FILE #: SI-2023-00207 PROJECT #: PR-2019-002677

Carlisle Crossing Site Redevelopment

RE: PROJECT – 2100 CARLISLE BLVD NE CORNOR OF CARLISLE BLVD & INDIAN SCHOOL RD NE (FORMER KMART SITE) – ALBUQUERQUE, NM. 87110

ADMINISTRATIVE AMENDMENT TO SITE PLAN FOR BUILDING PERMIT

ADMINISTRATIVE AMENDMENT

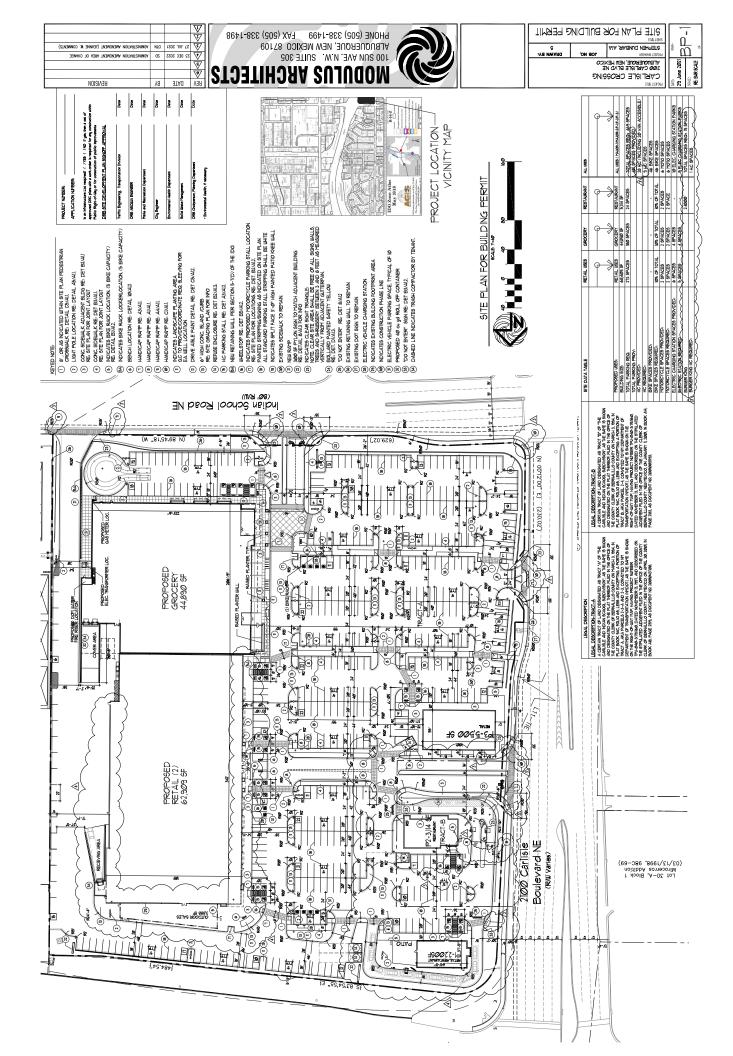
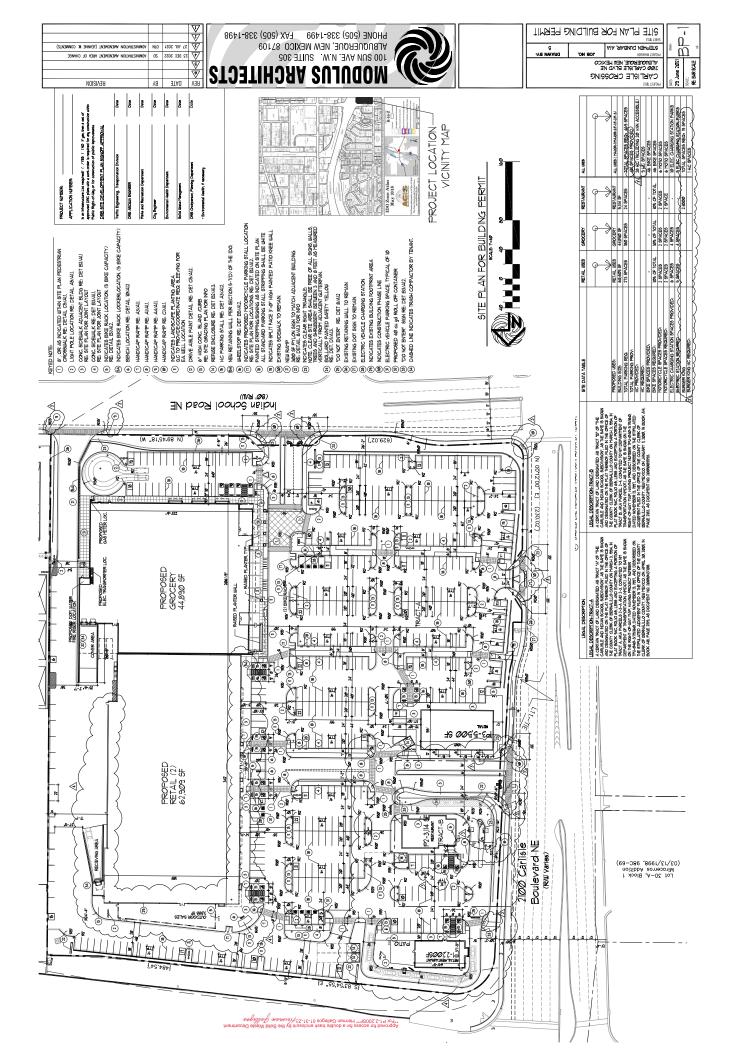
Remove parking spaces and landscaping area on North facade and replace with a 2

Addition of (1) loading dock to east side of proposed retail pad; Additional doors/acc

Addition of (1) new parking space in front of building (P1); Addition of (1) trash enclo

American Home Furniture Elevations modified; Landscaping Plan modified to accor

Update to parking calculation table; Most of IDO 14-16-5-11 front façade requiremer

AMENDED PLANS

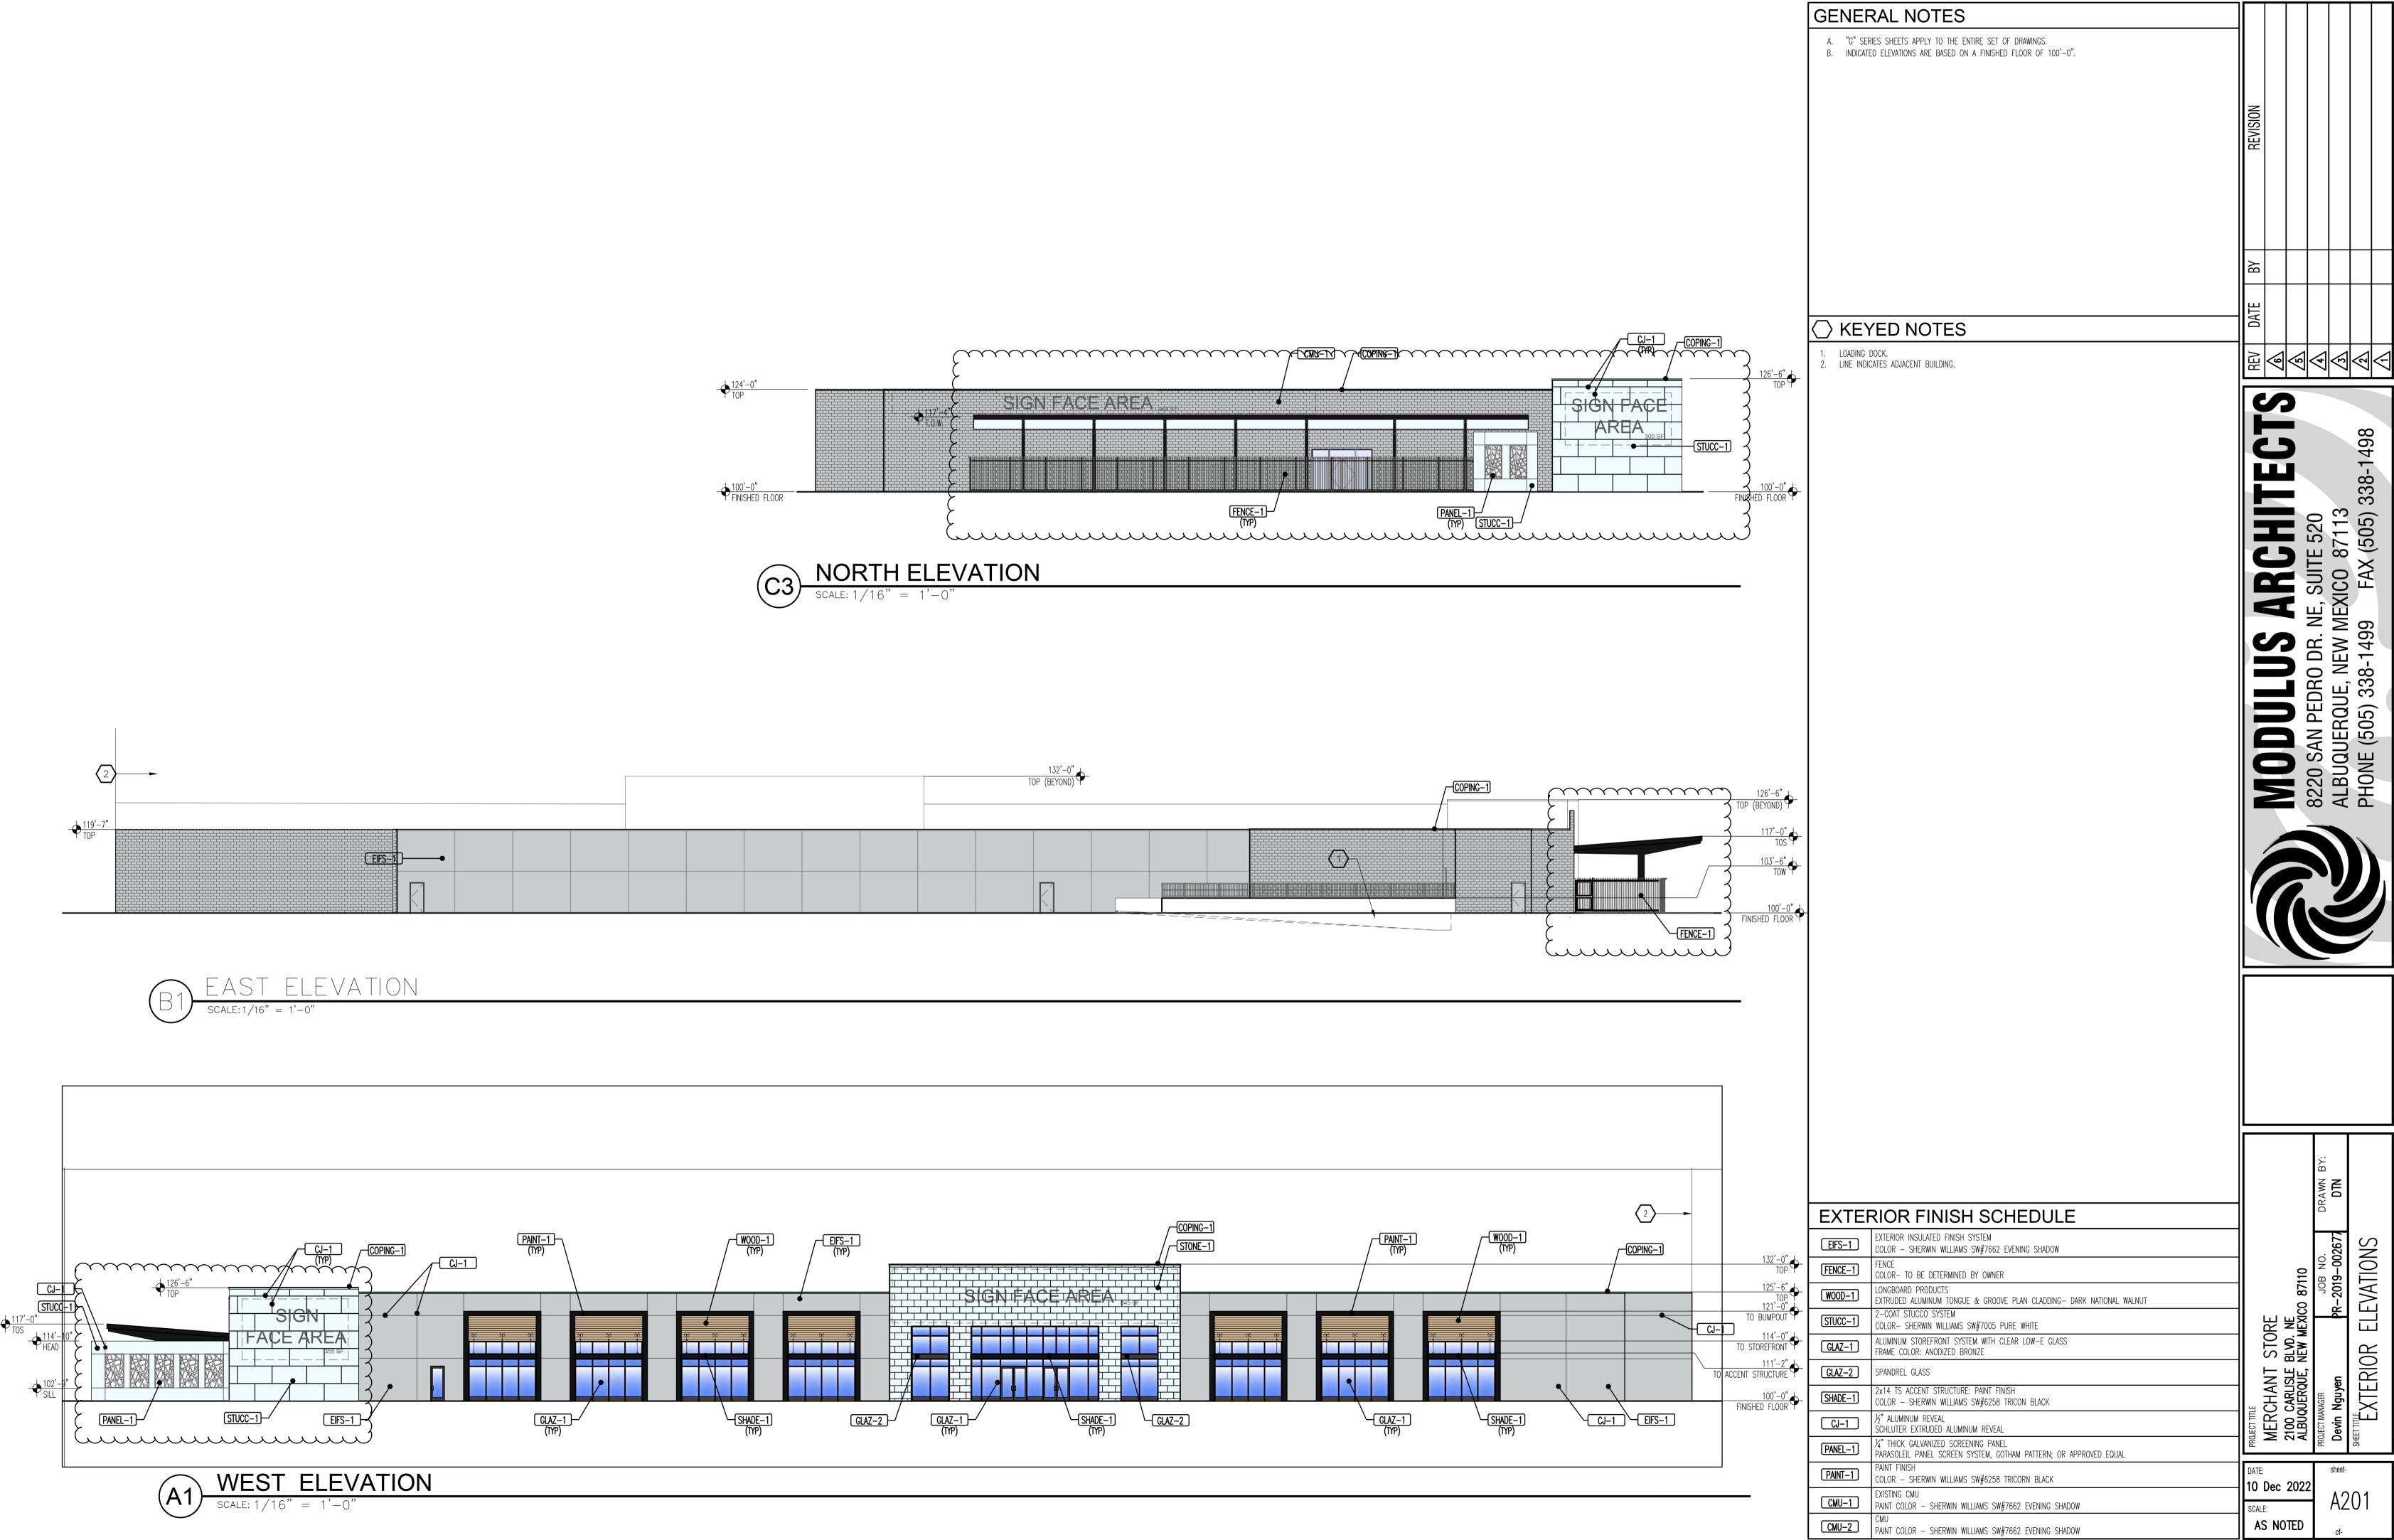
Site Development Plan:

- 1. The outdoor patio (3,888 sf) north of the retail use will be phased out of building development. The patio will be "Phase 2".
 - a. A door has been removed from the original patio.
- 2. 1 trash enclose will be added nest to the loading dock on the east side of the proposed retail pad.
- 3. A site work development phasing plan has been added to show the phasing of the site work. No other changes are proposed on this sheet just the phase lines.
- 4. The corner of the retail pad has been modified.
- 5. The Parking Calculations table has stayed the same. No parking has been modified with this request.
